CITY OF SUPERIOR, WISCONSIN
 DEPARTMENT OF PUBLIC WORKS

CONTRACT NO. 3
 LIFT STATION 5 AND STORAGE PLAN

CONTRACT NO. 3
LIFT STATION & STORAGE IMPROVEMENTS

LIFT STATION & STORAGE IMPROVEMENTS

ULTRASONIC LEVEL METER

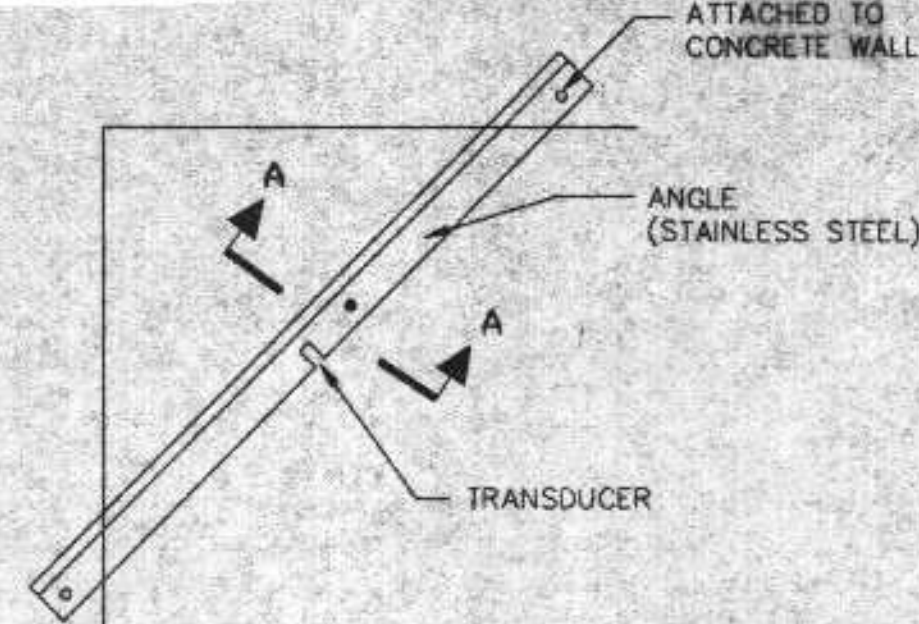
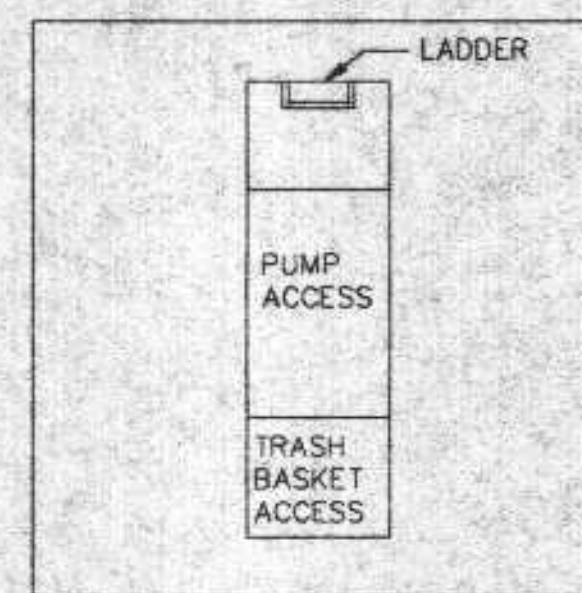
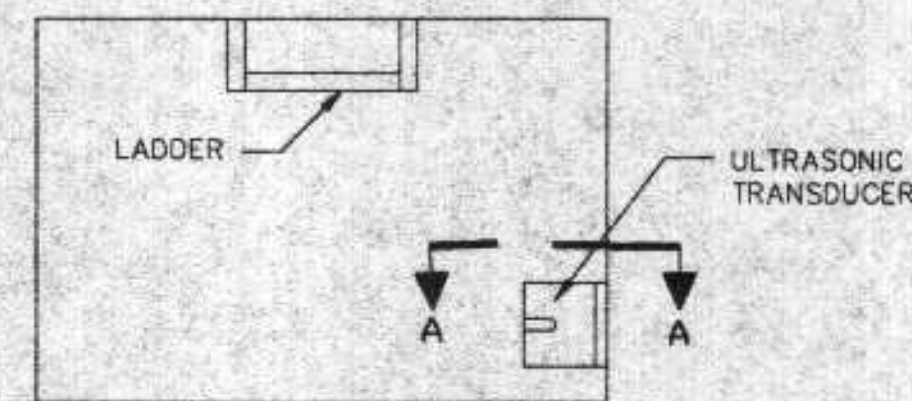
- Remove davit crane drawing and information (see revised crane in Item 6 of Specifications above).
- Rename Ultrasonic Level Meter Drawing as Level Meters and modify Section A-A with the following:

Ultrasonic Level Meter Transducer Bracket/Assembly Notes:
 1. All hardware and brackets to be stainless steel.
 2. 1/4" lip to be provided on bracket.

Float Tree Bracket/Assembly Notes:
 1. Float tree cable to be stainless steel and attached to 1/4" stainless steel plate for placement on bracket.
 2. All hardware and brackets to be stainless steel.
 3. 1/4" lip to be provided on bracket.
 4. Stainless steel handle for lifting of float system to be provided.

LIGHT POLE

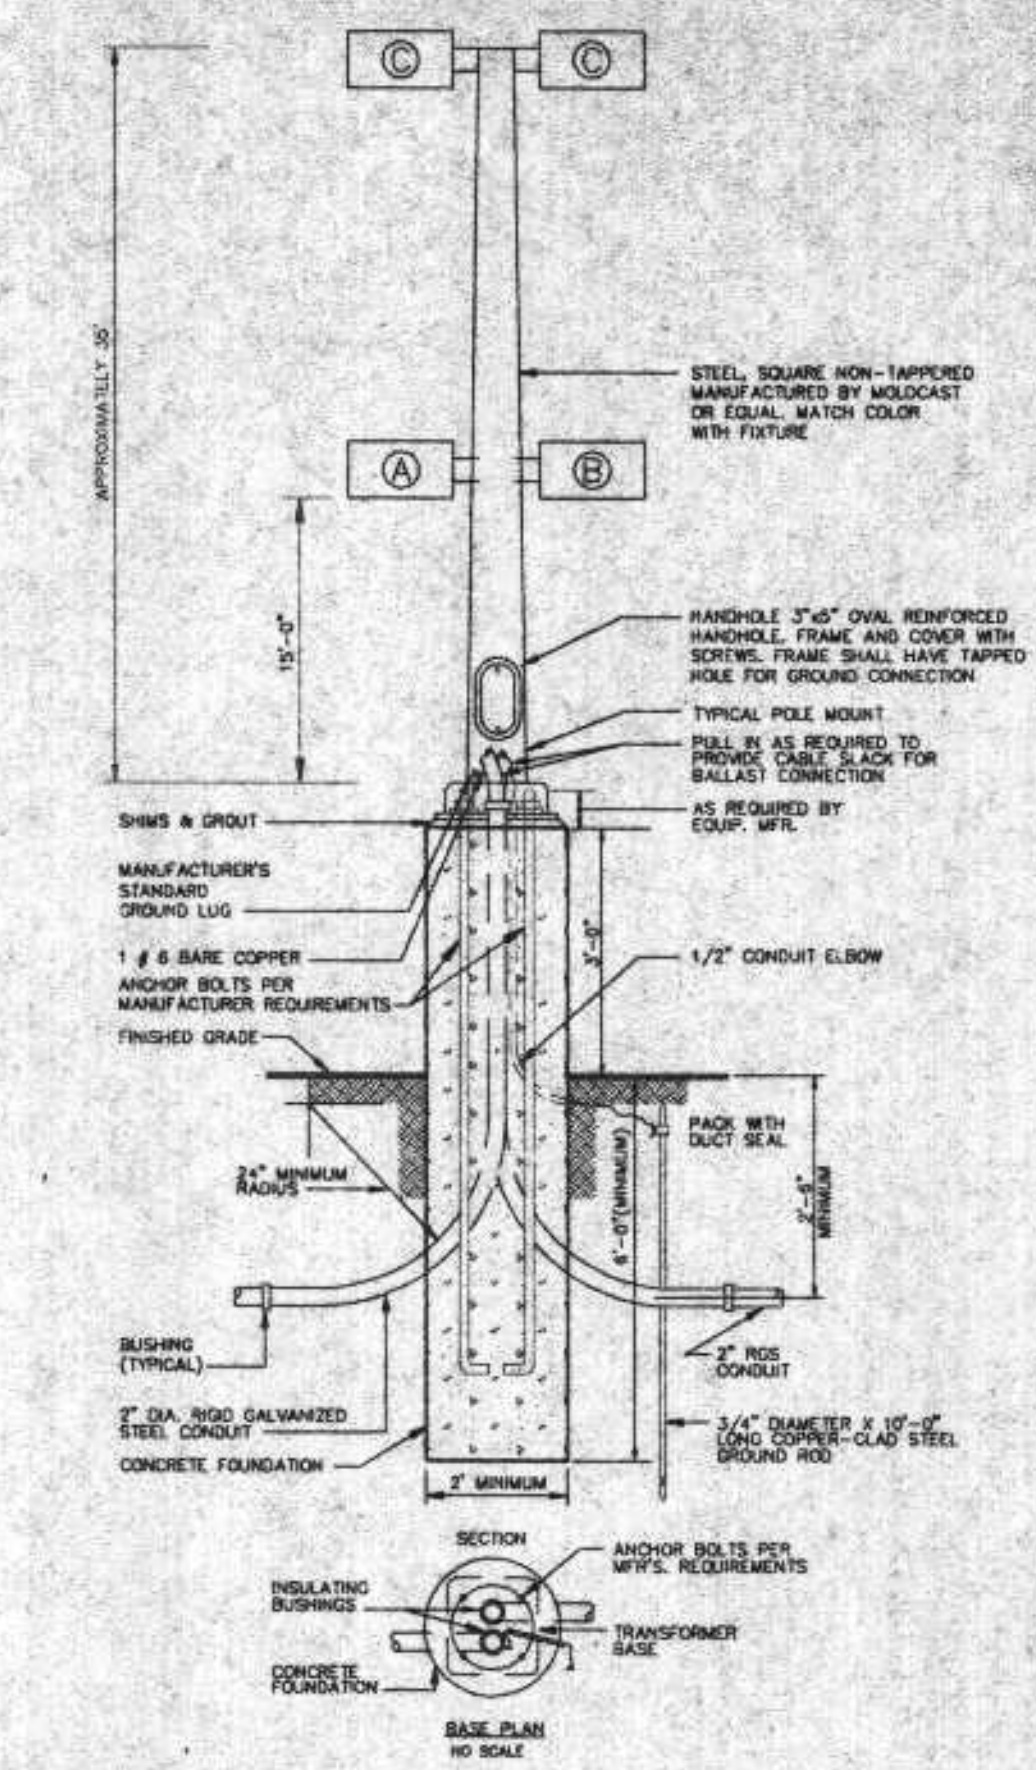
Add following to light pole drawing:

- 120 V, 20 Amp, GFCI, weatherproof duplex receptacle to be provided at base of all light poles. Receptacles to be switched at control panel.
- Switches to control yard lighting to be housed in control panel.

PUMP SCHEDULE

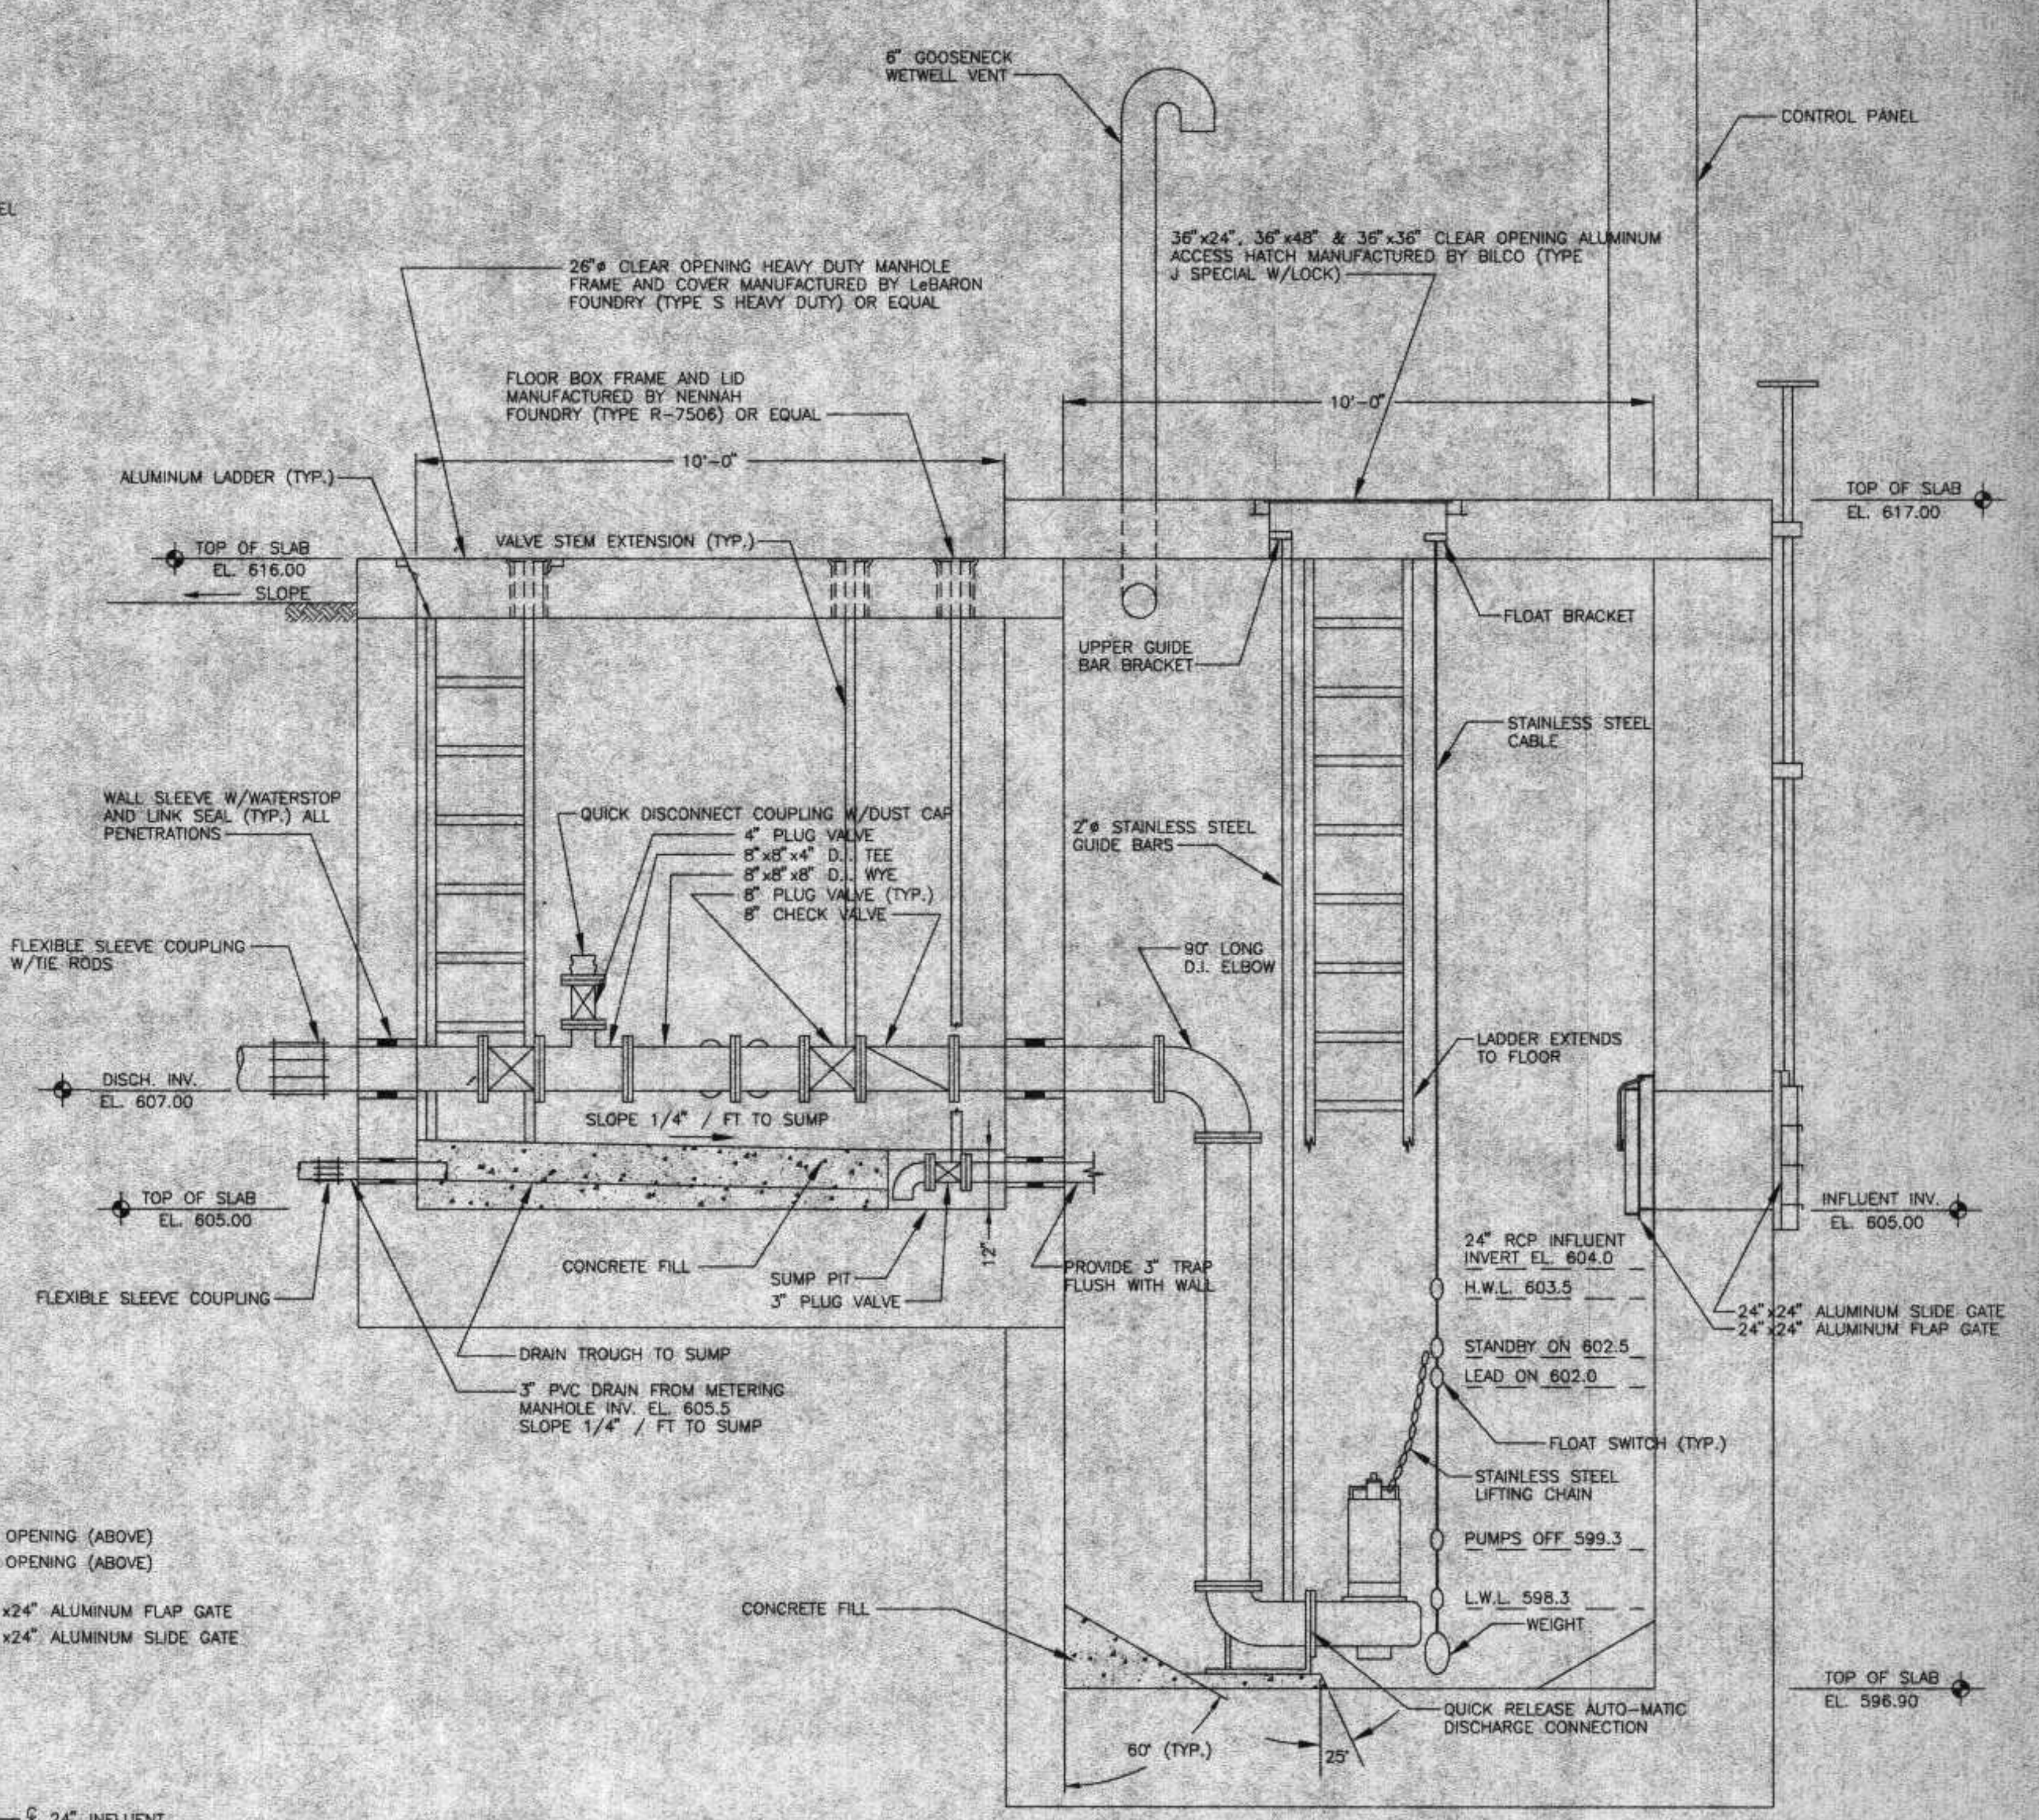
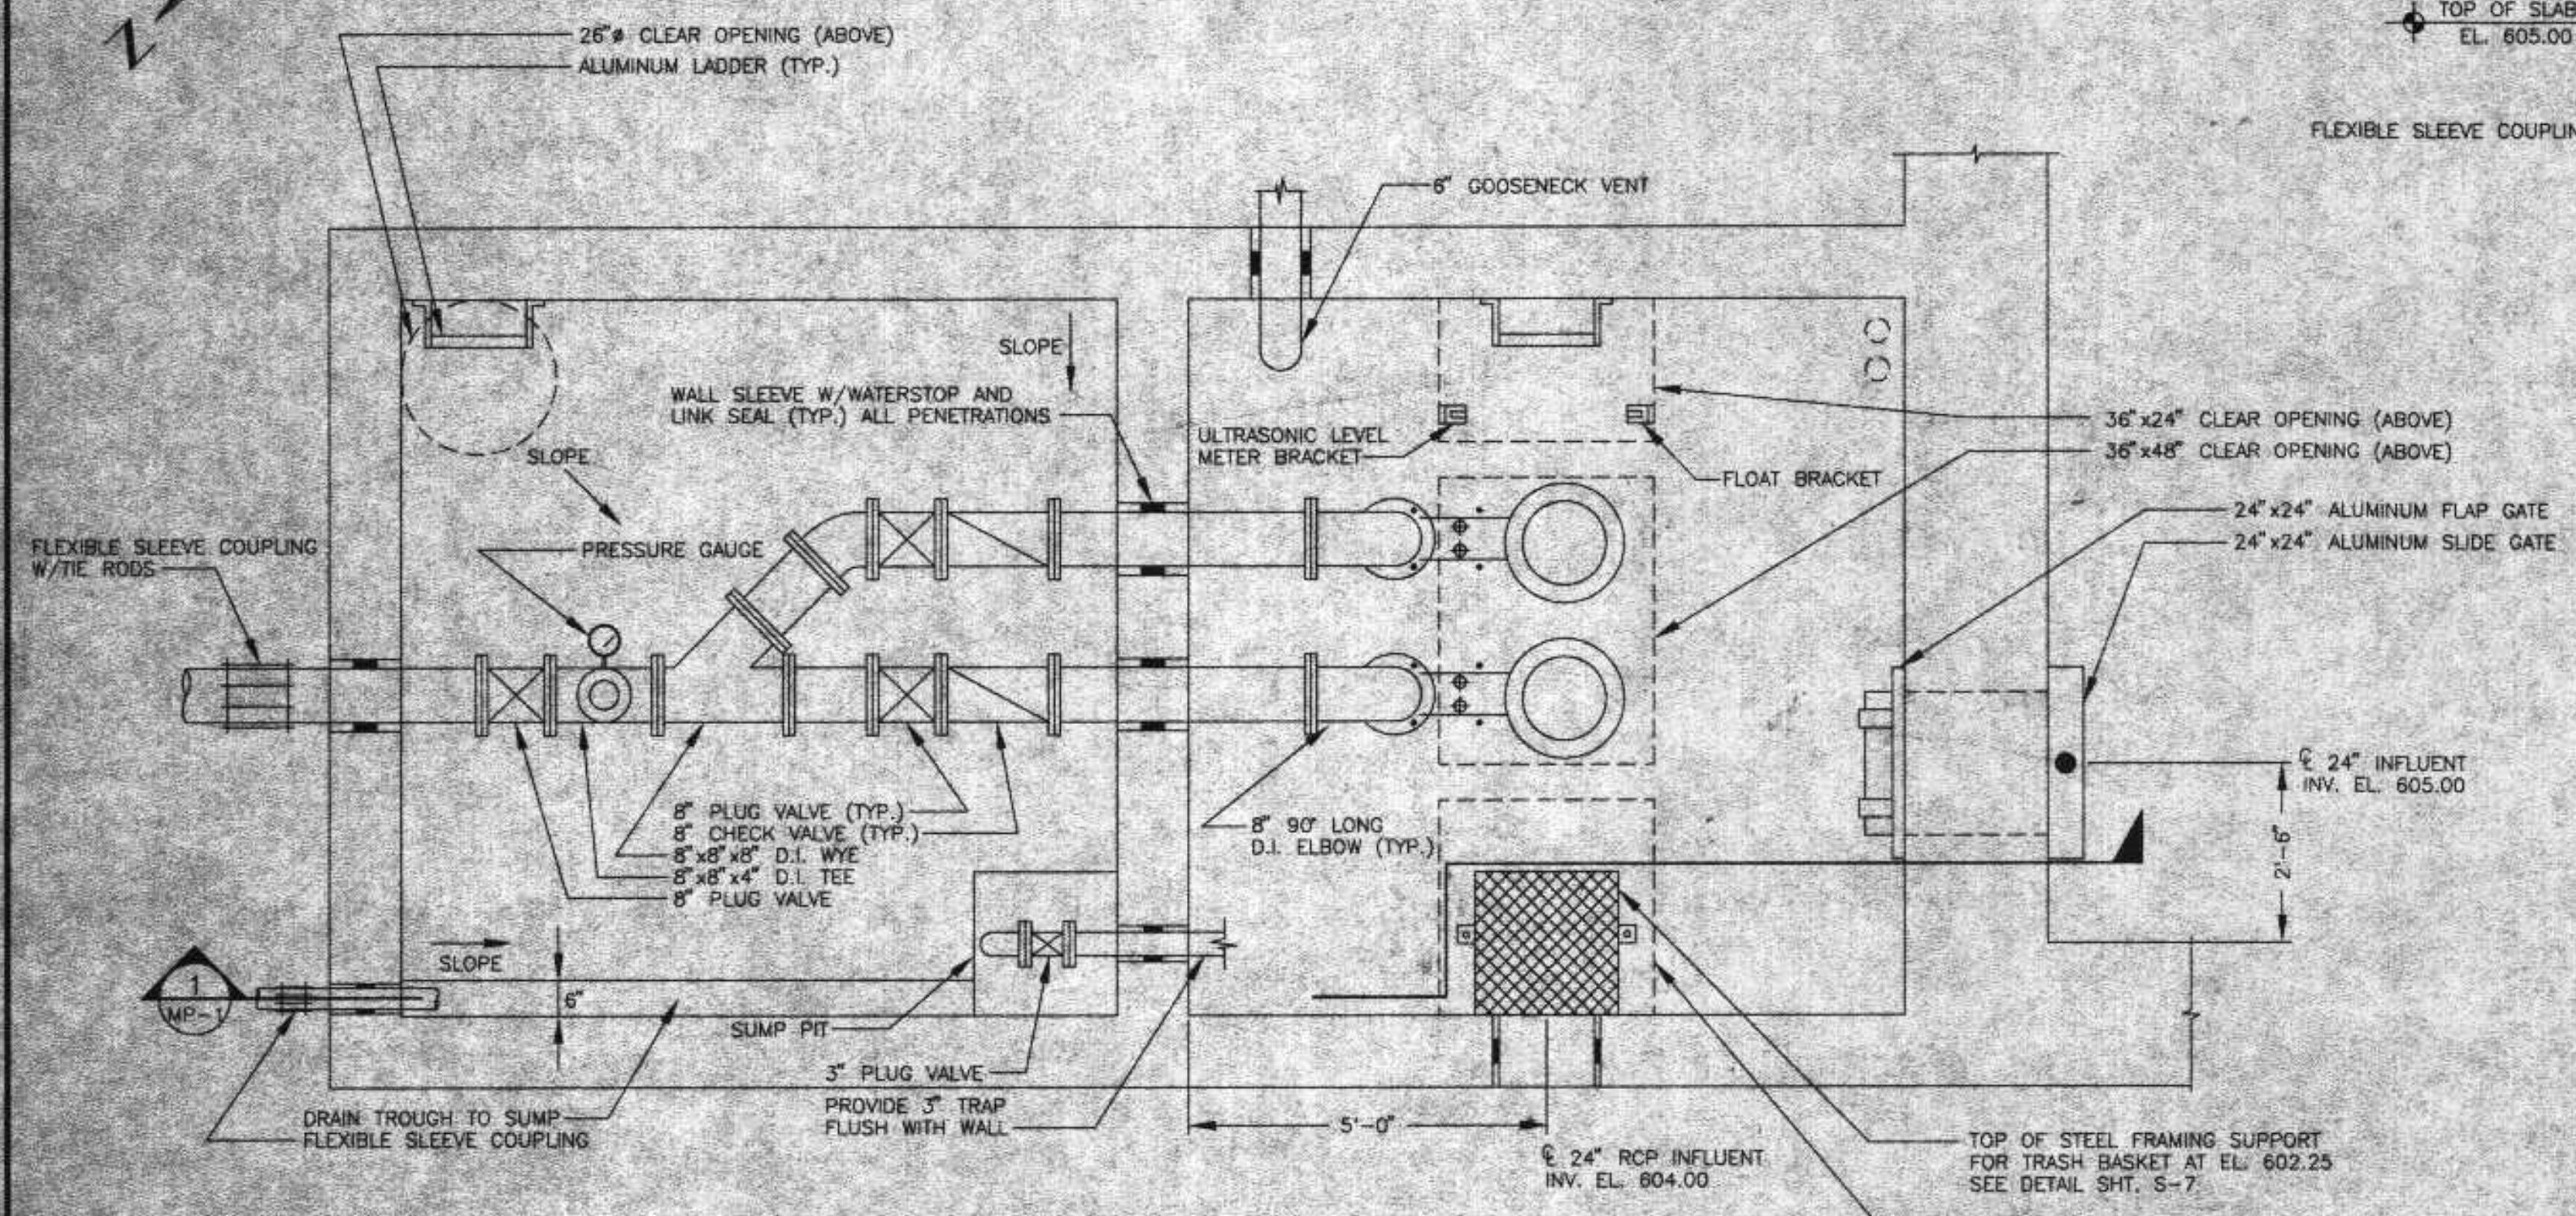
1. Replace Pump Schedule with the following:

LOCATION	NAME	QTY.	TYPE	RATING POINTS	MINIMUM DISCHARGE (INCHES)	MAX. PUMP RPM	MAX. HP	SEAL TYPE
L.S. 5	sewage pump	2	submersible recirculating	single: 1075 gpm @ 37" discharge: 1500 gpm @ 47" discharge: 2000 gpm @ 50" discharge: 1100 gpm @ 62" discharge: 350 @ 62" discharge: 450 @ 62"	6"	1745	20	double mechanical
L.S. 6		2			6"	1750	20	DOUBLE MECH.
L.S. 7		2			4"	1748	10	DOUBLE MECH.
